The following is my (our) itemized proposal.
 HSIP-0070-04(029)/ 109378301000
 Lafayette County(ies)

ADDENDUM

PROJECT NO.: HSPF-0070-04(029)

SUMMARY OF REVISIONS

SHEET ID: WK-3
 SHEET NO.: 24

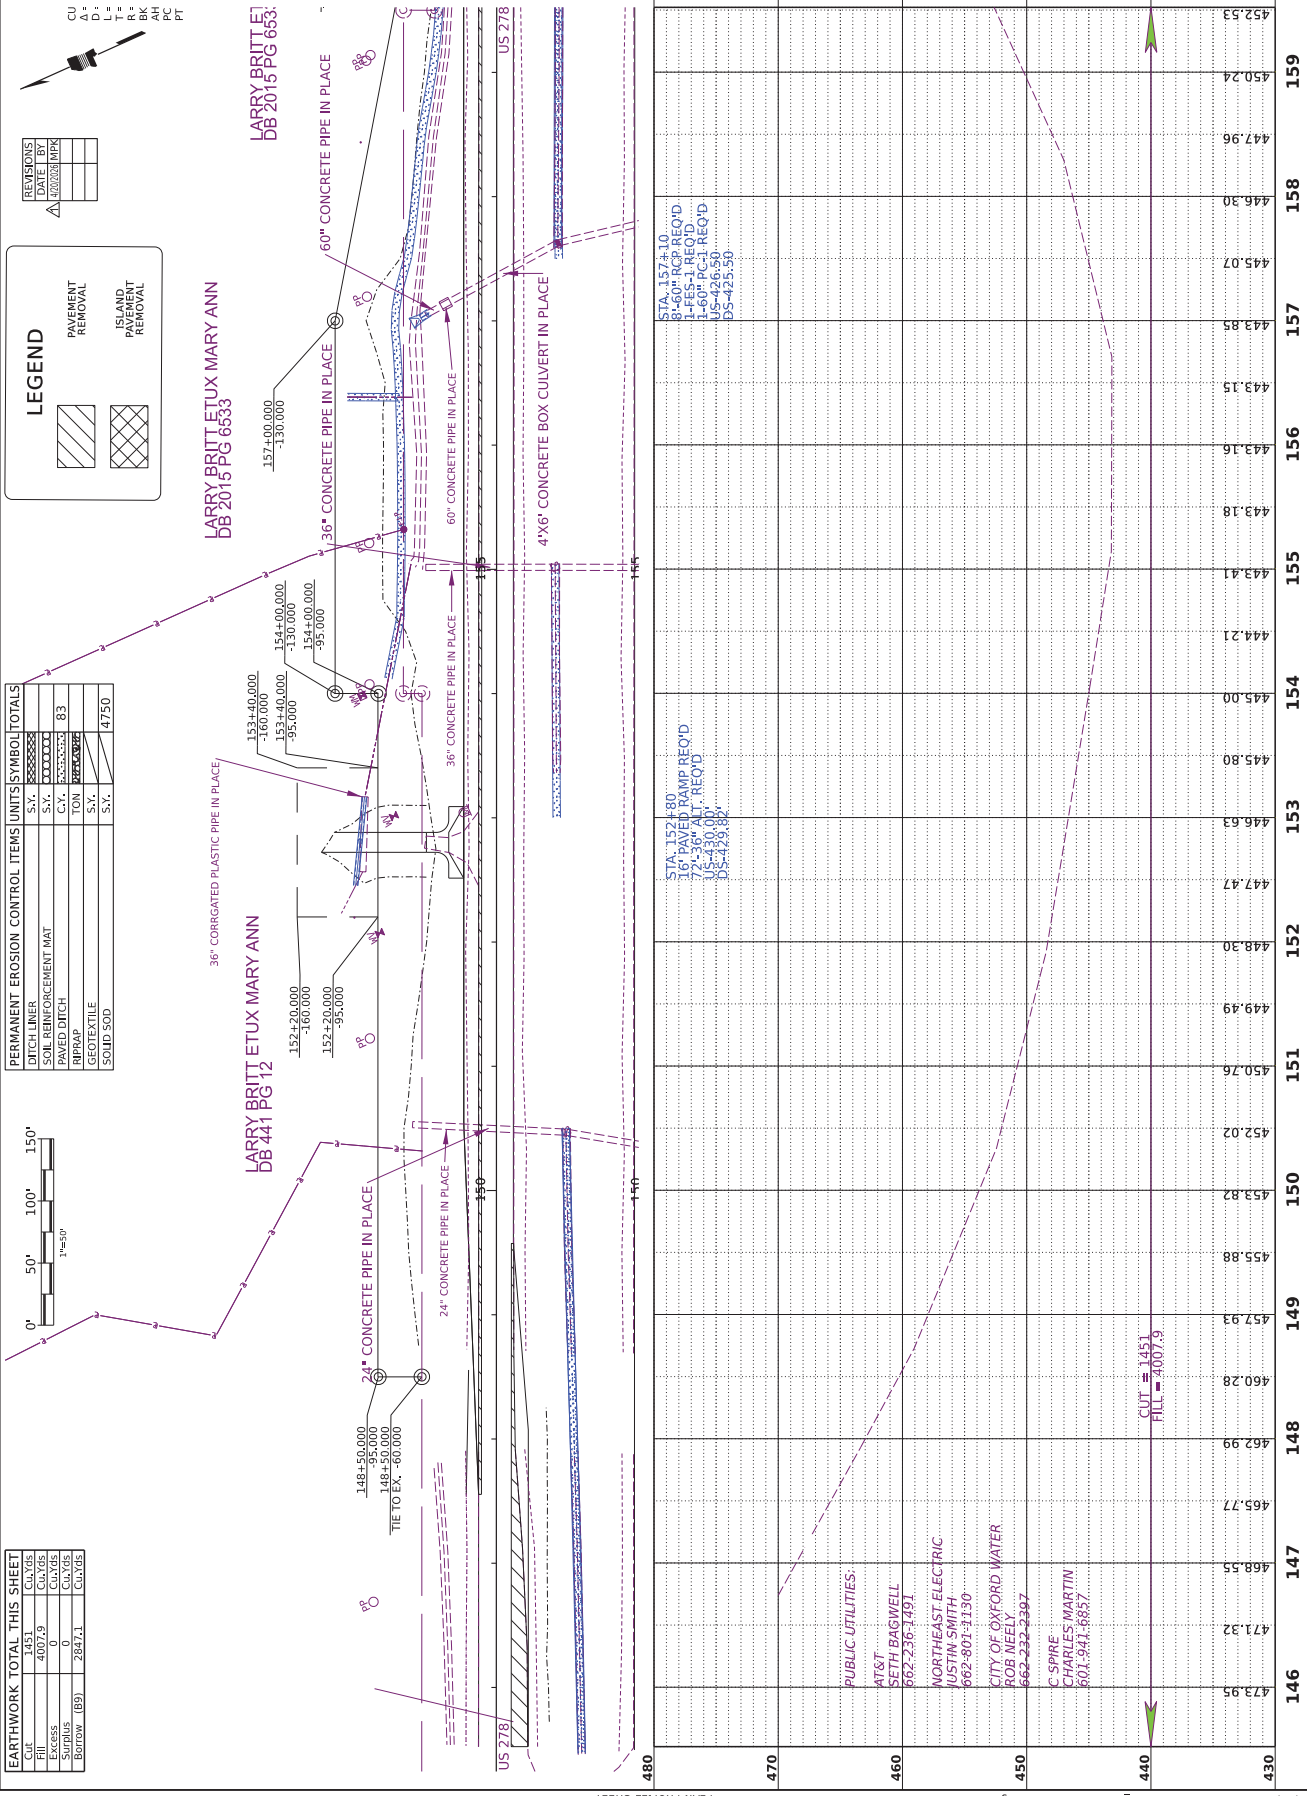
REV. NO.	DATE	1ST ORDER	ADDENDUM	2ND ORDER	INITIALS	SHEET ID.	DESCRIPTION
1	4/20/2028		X		MPK	TB1-TB2 WK-3 ECS-1 9001-9002	Revise Dimension. Revised Detail Notes in Profile View. Added GPS/Control Notes. Report of Cross Sections
